Re: Addendum to Recreation Facilities Inventory and Assessment Report, Turners Falls Hydroelectric Project (FERC No. 1889) and Northfield Mountain Pumped Storage Project (FERC No. 2485)

# **RELICENSING STUDY 3.6.2**

# **RECREATION FACILITIES INVENTORY AND ASSESSMENT ADDENDUM**

**Northfield Mountain Pumped Storage Project (No. 2485)  
and Turners Falls Hydroelectric Project (No. 1889)**

### Site 12: Northfield Mountain Tour and Trail Center (NMTTC)

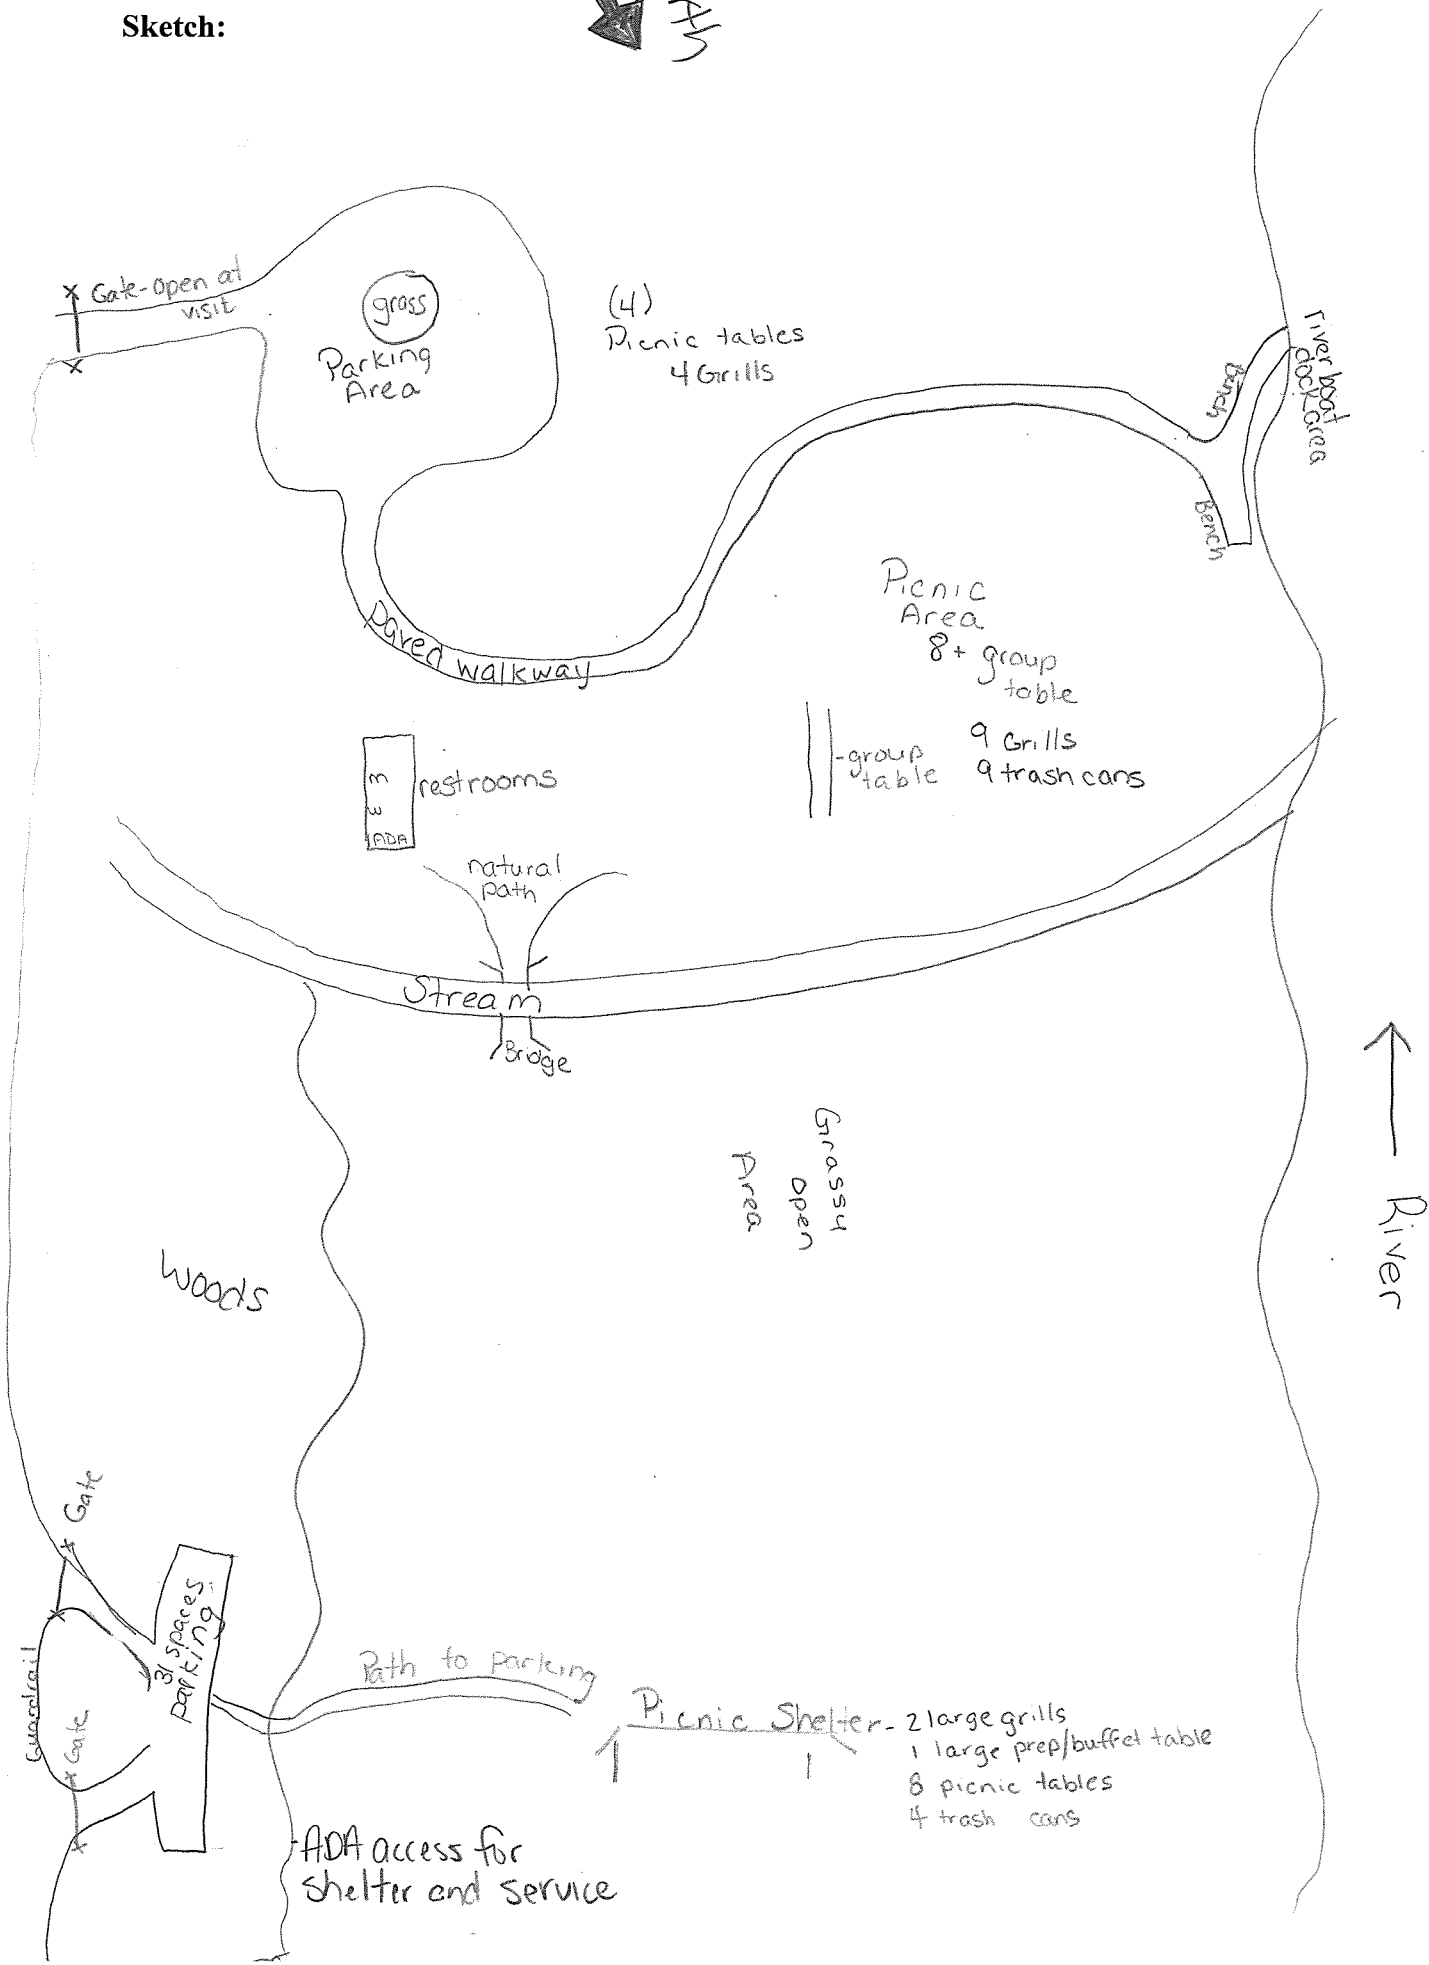
Commenter	Comment	Original Response/Information	Updated Information
Appalachian Mountain Club (AMC)  AMC-5	Site 12 – The Northfield Mountain Visitor Center inventory does not include access/facilities at the rock climbing areas.	Once on the Licensee’s property, climbers access the climbing areas over the existing Northfield Mountain trail system. A trail assessment for Northfield Mountain is being conducted under Study Plan 3.6.7. The Licensee does not provide or promote any climbing routes or specific facilities, other than the trails for access, on their property for this activity. Parking areas and trailheads outside the Project, and therefore non-Project facilities, were not inventoried as part of Study 3.6.2. However, user counts were conducted and user surveys were administered at these sites in order to estimate level of climbing activity and climber perceptions.	Inventory and assessment information about two climbing sites, the Rose Ledge Climbing Area (Site 27) and Farley Ledge Climbing Area (Site 28) is provided in the 3.6.2 Study Addendum (see Section 5.3). Both the climbing areas are located within or partially within the Northfield Mountain Project boundary. The Rose Ledge climbing area can be accessed several ways including via the NMTTC trail system. Both climbing sites are informal sites, with no improvement or formal facilities or amenities. Both sites were inventoried and assessed, but as informal sites no formal condition assessment was made.

# Site 15: Barton Cove Nature Area and Campground

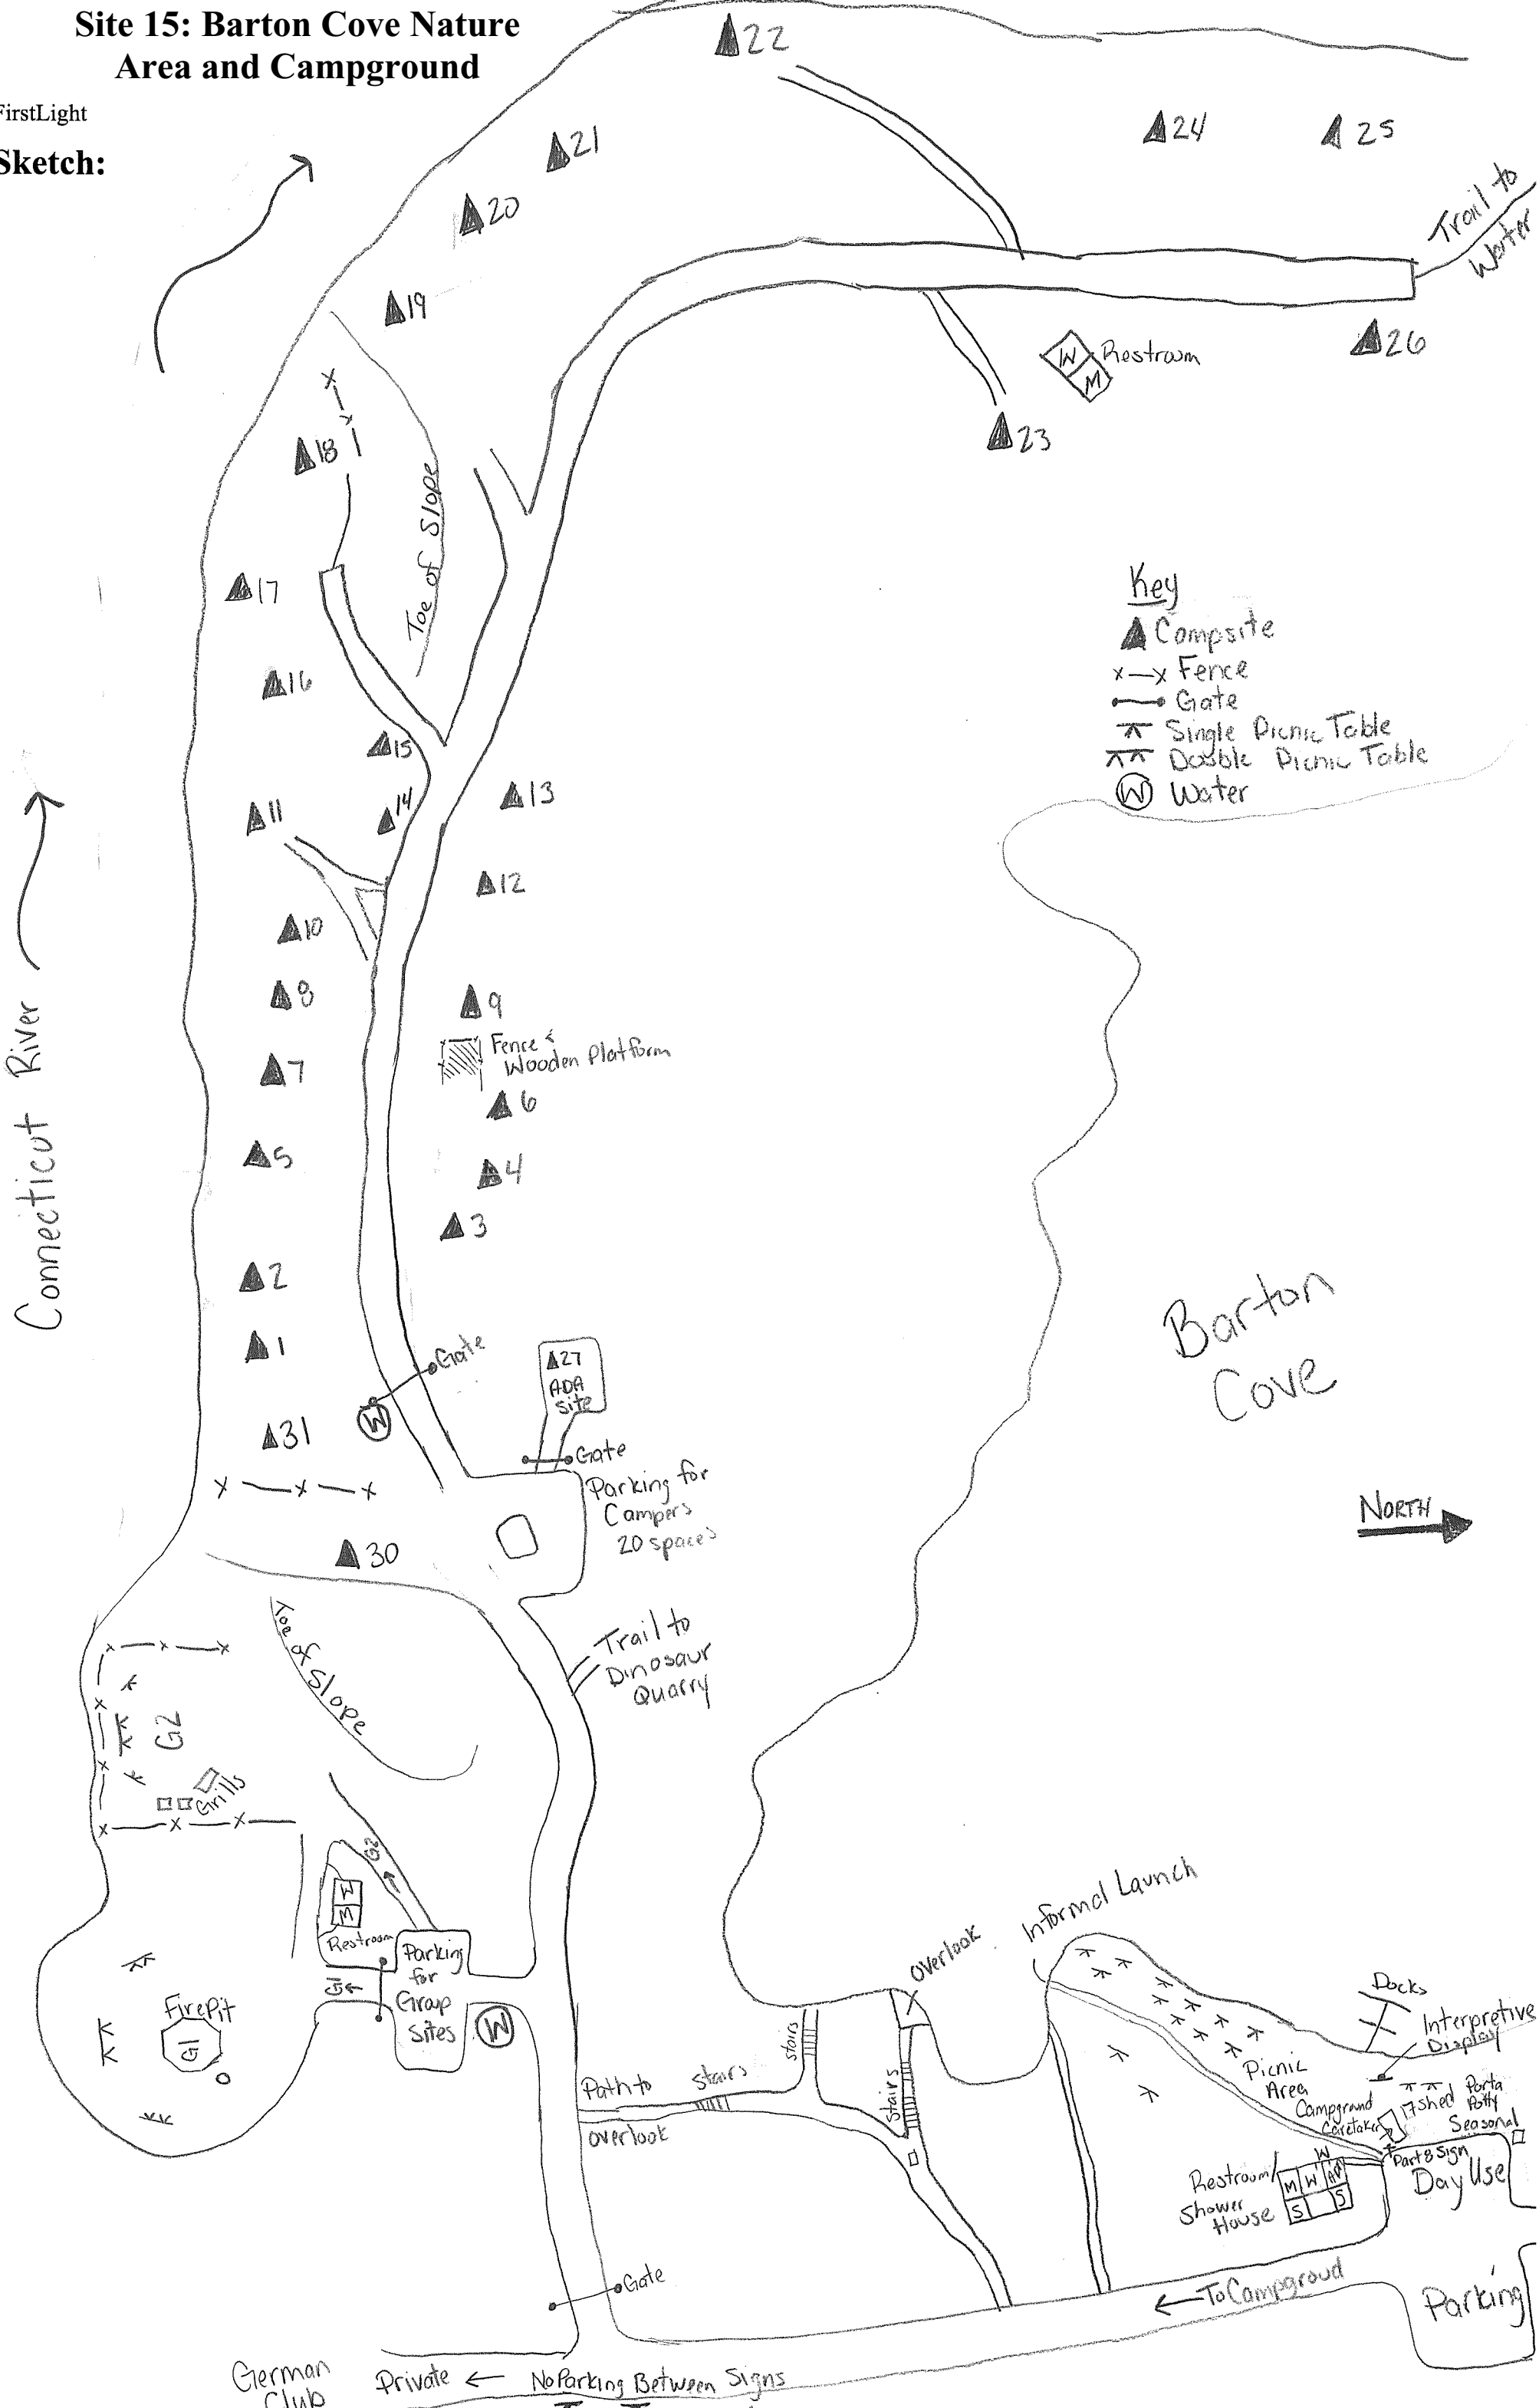
<p>CT River Watershed Council (CRWC) CRWC-4</p>	<p>Site 15: Barton Cove Nature Area and Campground. The survey was done when the facility was closed. No information is filled in the field sheet for this site under “site facilities” – no mention of showers or the condition they were in, no mention of grills, picnic tables, or parking areas, or the condition of them.</p>	<p>Although the study was conducted in the off season, FirstLight staff accompanied the team to this location and unlocked the bathrooms for the inventory. The bathrooms were observed to be in good, functioning condition, with no issues noted. Showers were recorded on the Barton Cove Nature Area Inventory form, as well as some of the grills and</p>	<p>As part of the 3.6.2 Study Addendum, more detailed field site maps were created for the formal recreation sites, including the Barton Cove Nature Area and Campground. The revised field site map for this site shows the location of grills, picnic tables and parking areas (see Appendix A).</p>

Commenter	Comment	Original Response/Information	Updated Information
		picnic tables. Site facilities at the campground were recorded on the map along with the inventory form. There were no issues at the time of the inventory with the condition of these items.	
CRWC-7	Site 23: Cabot Woods Fishing Access. The site description states, "The access road along the canal is open to the public and is used for sightseeing." Note: this access road is used for fitness walking, dog walking, roller blading, bird watching, and bankside fishing in the canal. The field sheet indicates a flat gentle slope to the water. That may be true for the water in the canal, but not for the water in the bypass channel. The trails down to the water in the bypass channel are eroded and not maintained. The bypass channel is frequently used for informal swimming, something that would not have been determined during the October 17, 2011 site visit to fill out the form.	See response to AMC 10.	See response to AMC 10.

# Site 25: Poplar Street Access Site

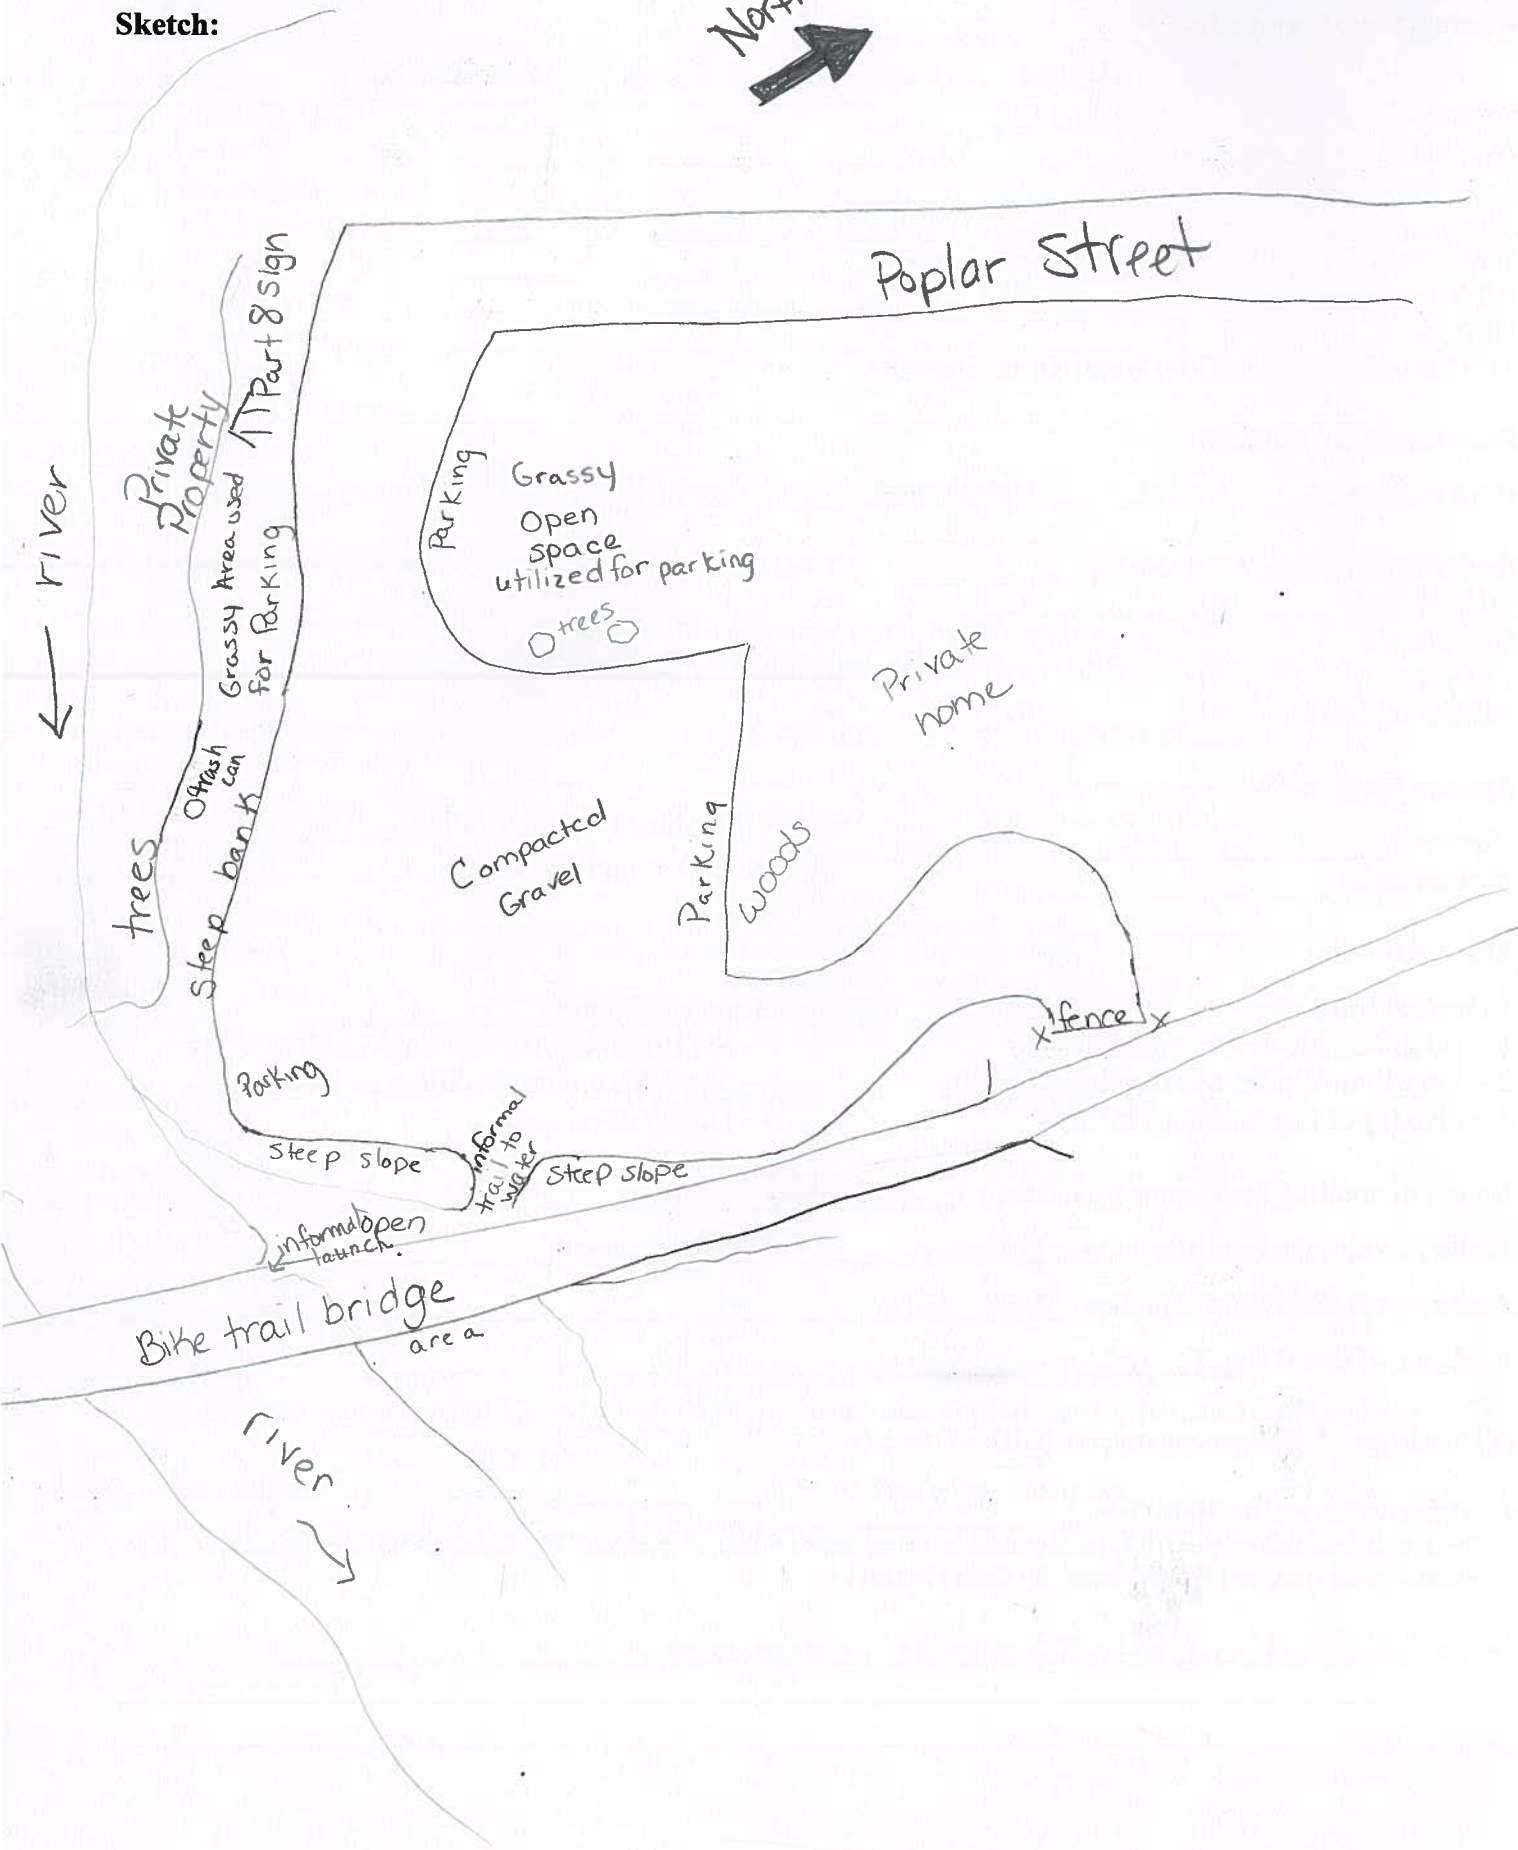
CRWC-8	Site 24: Turners Falls Canoe Portage. This site assessment would be better broken into site 16 for the take-out and site 24, which is the Poplar Street boat launch. The Poplar Street boat launch is also used as a put-in for paddling between Turners Falls and the Sunderland Bridge, the only section of river with speed limits for motor boats and a ban on personal watercraft. The field sheet says it has 4 spaces, but it has more than 4. Because parking spaces are not marked, it appears the person completing the survey	There were no improvements to assess the condition of the Poplar Street Site at the time of the site visit. Evidence of overcrowding at this site would have included compaction, erosion, refuse or other typical indicators in the parking area at the time of the visit. The erosion and compaction noted at the site were attributed to users traveling down the embankment and not to overuse. There was no other evidence of overuse. See response to AMC-1.	See responses to AMC-12.
